Access Compliance Report

Public Rights-of-Way

(Curb Ramps)

Intersection ID: 7669	Main Street: GRIER_RD	Cross Street: NICOLET_GLEN_DR	Location: SE
ADA ID: 5E45CE5625F6	Ramp Type: Perp	Initial Pass/Fail: Pass	Overall Compliance: No
Severity Score: 5			
Codes/Mitigation Info/Possible Solution		Field Measurements/Component Compliance

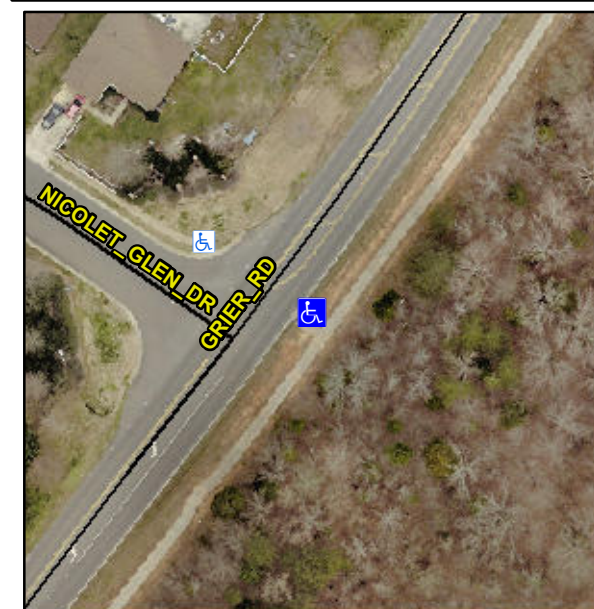
**R304.2.2-Perp, R304.3.2-Para,
R304.5.3, R302.7, R304.5.4**

Compliance	Description	Data	Compliance	Description	Data
N/A	Ramp Length (in)	179.0	Yes	Ramp Slope (%)	6.0
Yes	Ramp Width (in)	72.0	Yes	Ramp XSlope (%)	0.6
N/A	Flare Type LT	None	N/A	Flare Type RT	N/A
N/A	Flare Slope LT (%)	N/A	N/A	Flare Slope RT (%)	N/A
N/A	Flare Traversable LT?	N/A	N/A	Flare Traversable RT?	N/A
Yes	Landing Length (in)	72.0	Yes	DWS Provided?	Yes
Yes	Landing Width (in)	72.0	Yes	DWS Contrast?	Yes
No	Landing Slope (%)	3.3	Yes	DWS Length (in)	24.5
No	Landing X Slope (%)	2.9	Yes	DWS Full Width?	Yes
N/A	Landing Curb? (Y/N)	No	Yes	DWS Offset (in)	0.0
N/A	Shared Landing?	No			
No	Gutter Ponding?	Yes	No	Gutter Slope (%)	6.3
Yes	Gutter Lip Ht (in)	0.0	Yes	Gutter X Slope (%)	1.0
N/A	Painted X Walk1?	No	N/A	Painted X Walk2?	N/A
	X Walk 1 Direction	To N		X Walk 2 Direction	N/A
N/A	X Walk 1 Width (in)	N/A	N/A	X Walk 2 Width (in)	N/A
	X Walk 1 Slope (%)	4.2		X Walk 2 Slope (%)	N/A
	X Walk 1 X Slope (%)	0.9		X Walk 2 X Slope (%)	N/A

N/A	Ramp inside XWalk1?	N/A	N/A	Ramp inside XWalk2?	N/A
	Road Slope (%)	N/A	N/A	Clear Space?	Yes
	Road X Slope (%)	N/A	N/A	Clear Space to XWalk (in)	N/A
Yes	Any Obstructions?	No	Yes	Storm Grate/Utility Hazard?	No
	Obstruction Type			Storm Grate/Utility Type	
			N/A		N/A
			Yes	Surface Condition? (G/P)	Good

**Remove & Replace Landing.
Remove & Replace Gutter.**
